2012 EVALUATION OF RECREATIONAL PARKS/PLAYGROUNDS

FOR
SAFETY INSPECTION – ADA COMPLIANCE

Borough of Tenafly
100 Riveredge Road
Tenafly, NJ 07670

MASER CONSULTING P.A.
331 Newman Springs Road, Suite 203
Red Bank, NJ 07701

SUNNYSIDE PARK

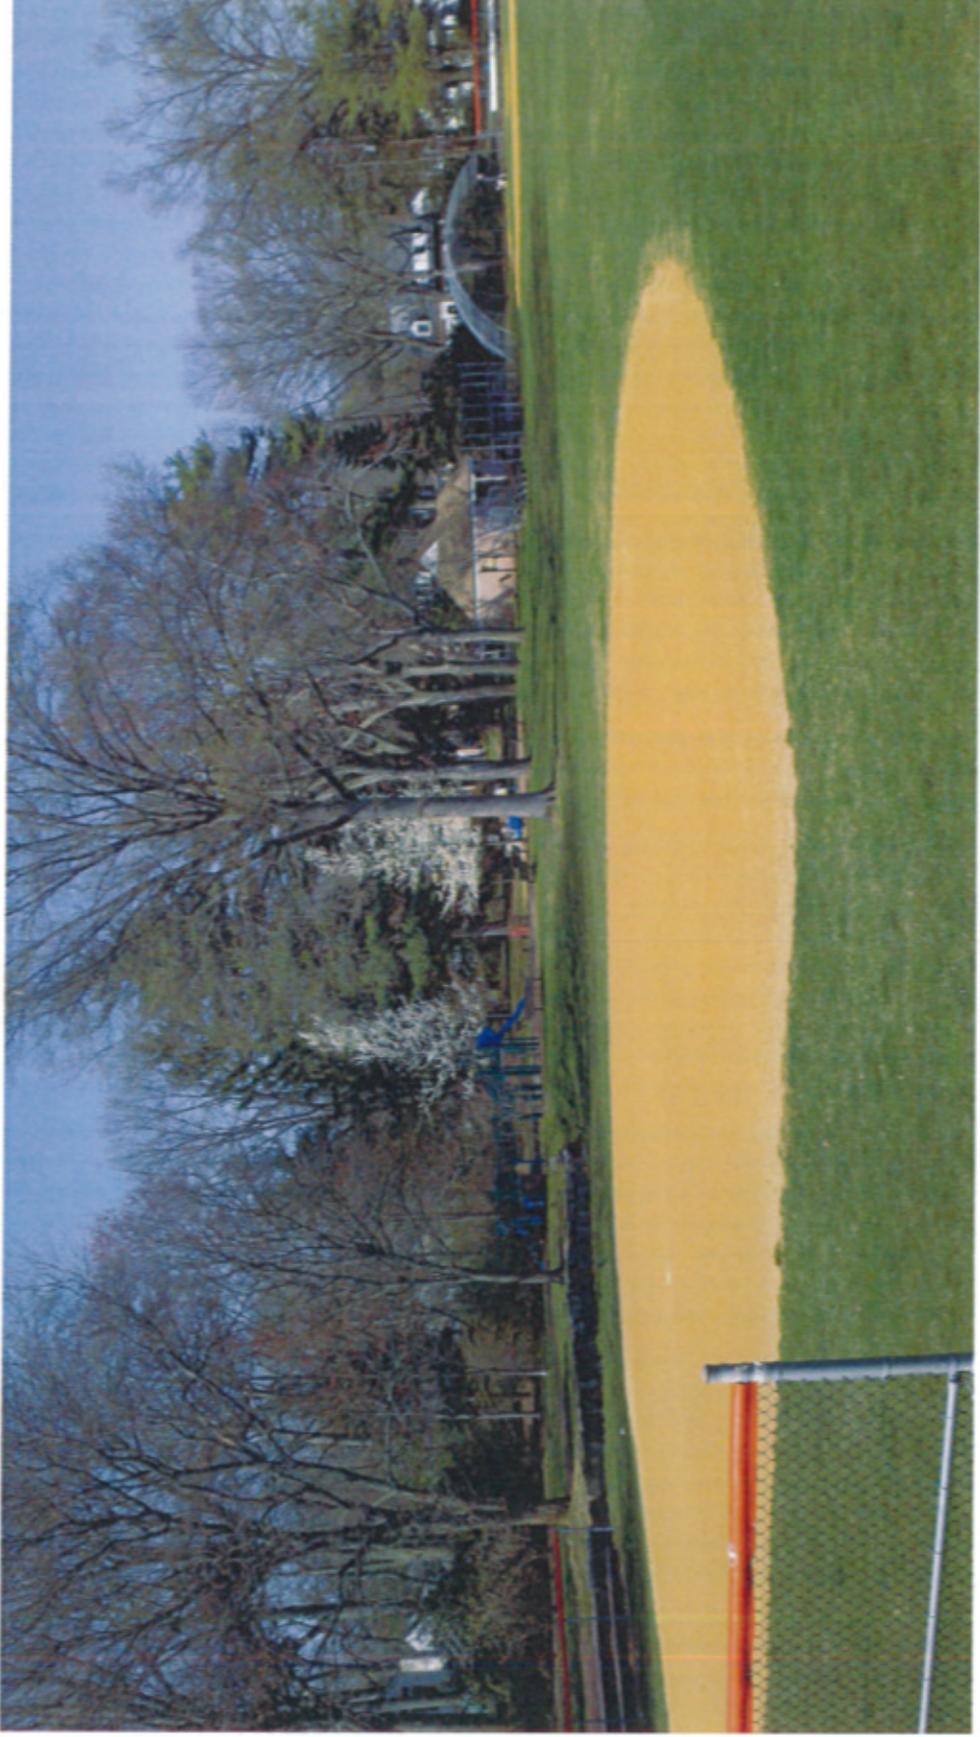
PROVIDE REQUIRED MAINTENANCE AND SUPPLEMENT PLAY SURFACE ON REGULAR BASIS

WALNUT PARK

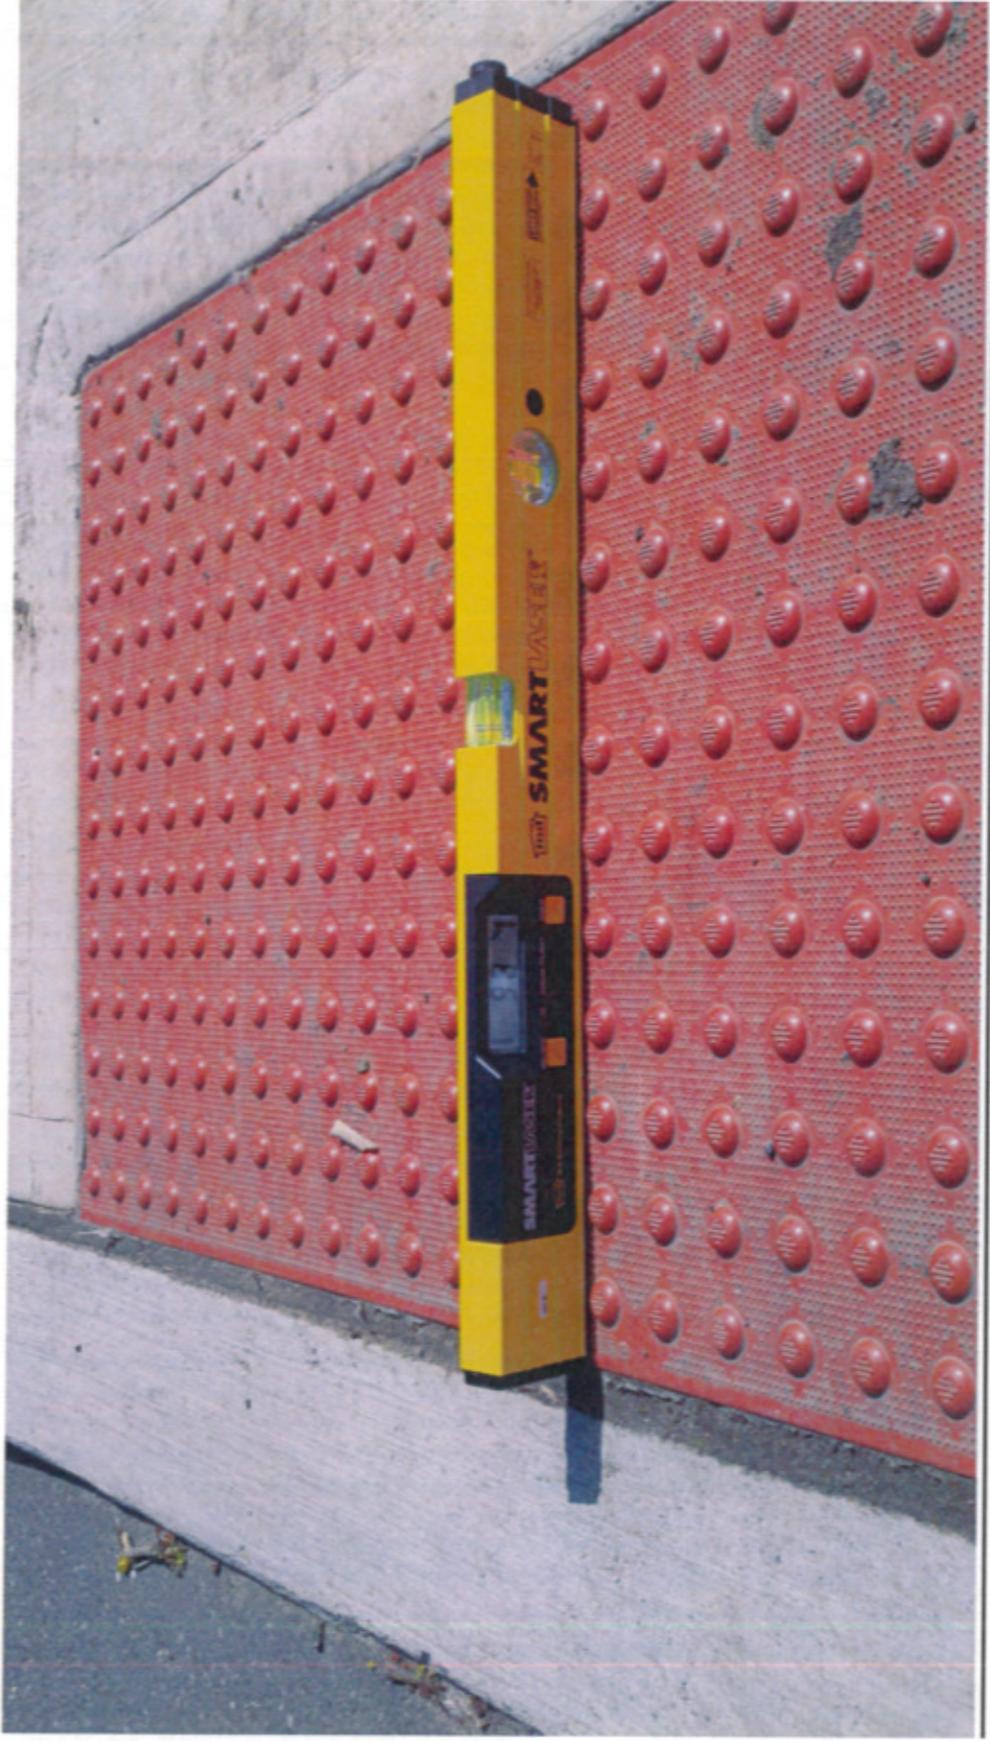
DAMAGED, SAND IN POOR CONDITION WITH LITTLE MAINTENANCE – REPAIR OR REMOVE
